Technical Service Bulletin: TSB130117

QSK45, QSK60, and QSK78 Eliminator™ Hydraulic Motor Outlet Restricted Coupling

Figure 1: Outlet Restricted Coupling, Part Number 3649824

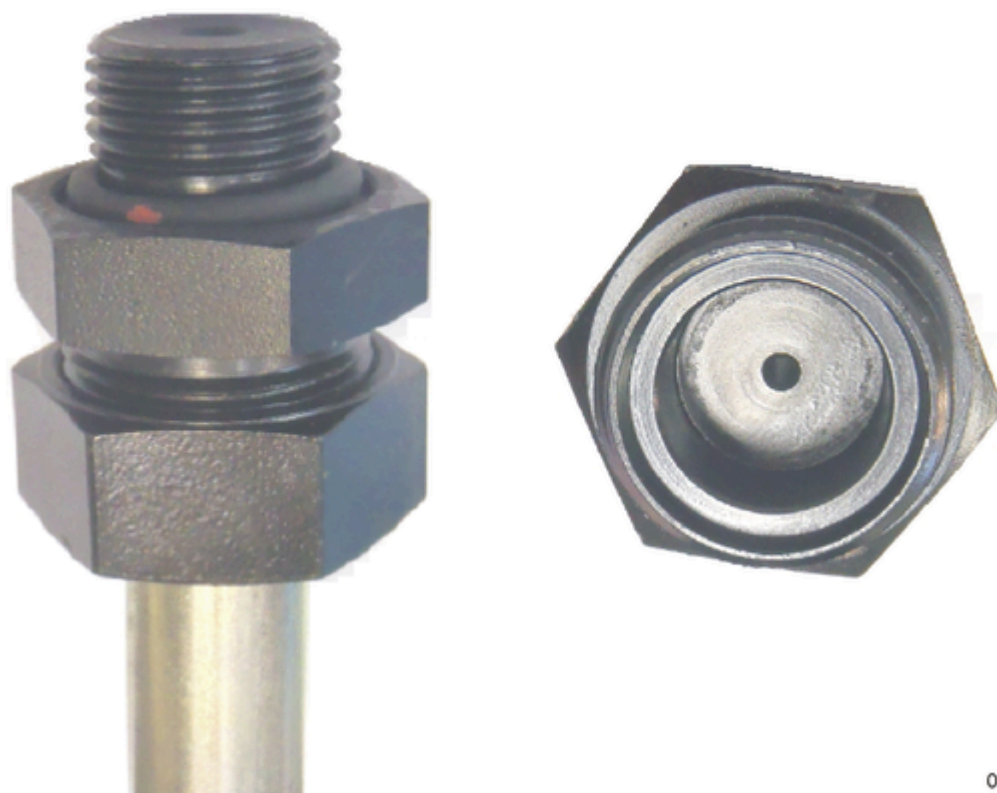
This document announces the release of an outlet restricted coupling (Figure 1) that is to be fitted to the Eliminator™ hydraulic motor on QSK45, QSK60, and QSK78 engines. The new part number can be found in Table 1.

¹Restricted coupling can be purchased separately for use with old motor return pipe.

Figure 2: Location of Outlet Restricted Coupling

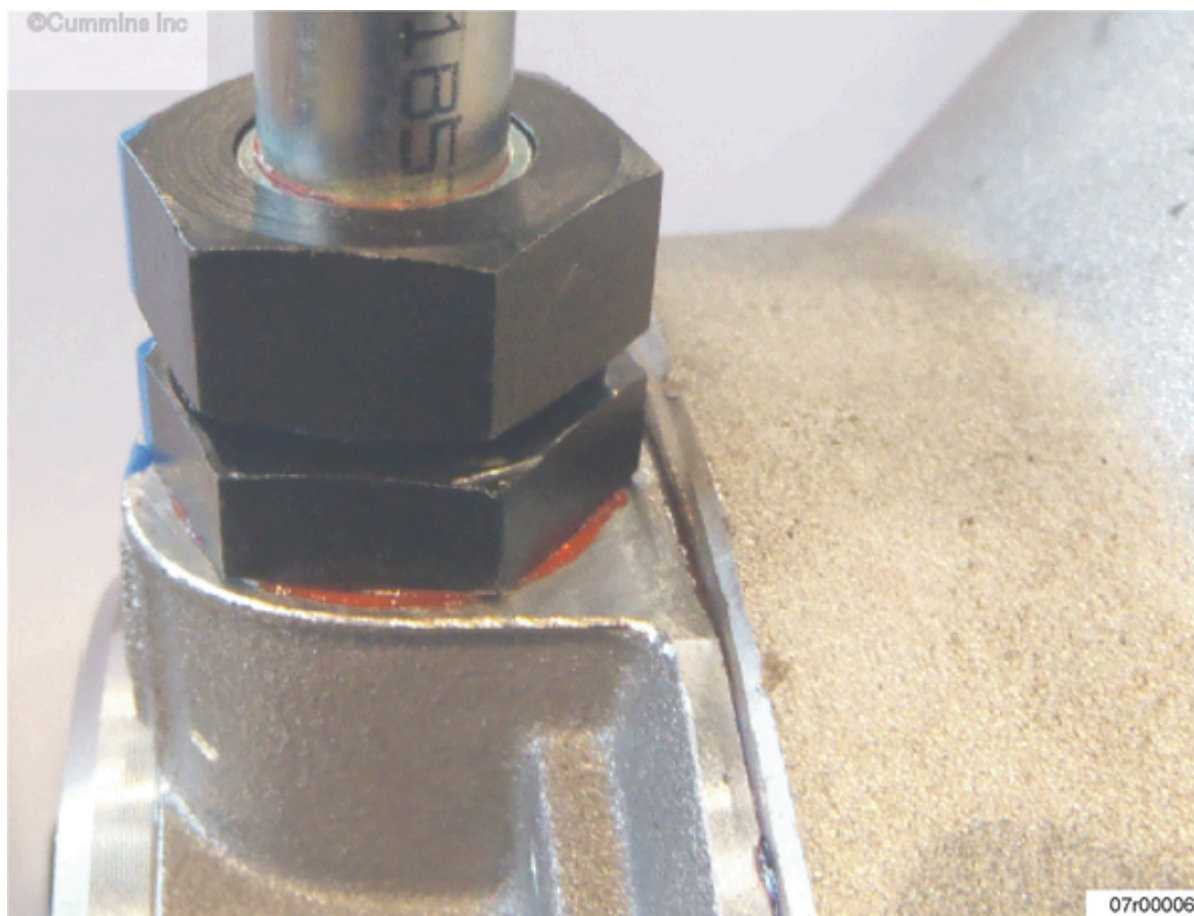
The restricted coupling has been released to slow the rotational speed of the Eliminator™ hydraulic motor. The outlet restricted coupling has a 1.8 mm [0.07 in] restriction and is fitted between the Eliminator™ hydraulic motor outlet and Eliminator™ hydraulic motor return line, as shown in Figure 2.

The new Eliminator™ hydraulic motor return line assemblies will come with the outlet restricted coupling already attached. The new part numbers can be found in Table 2.
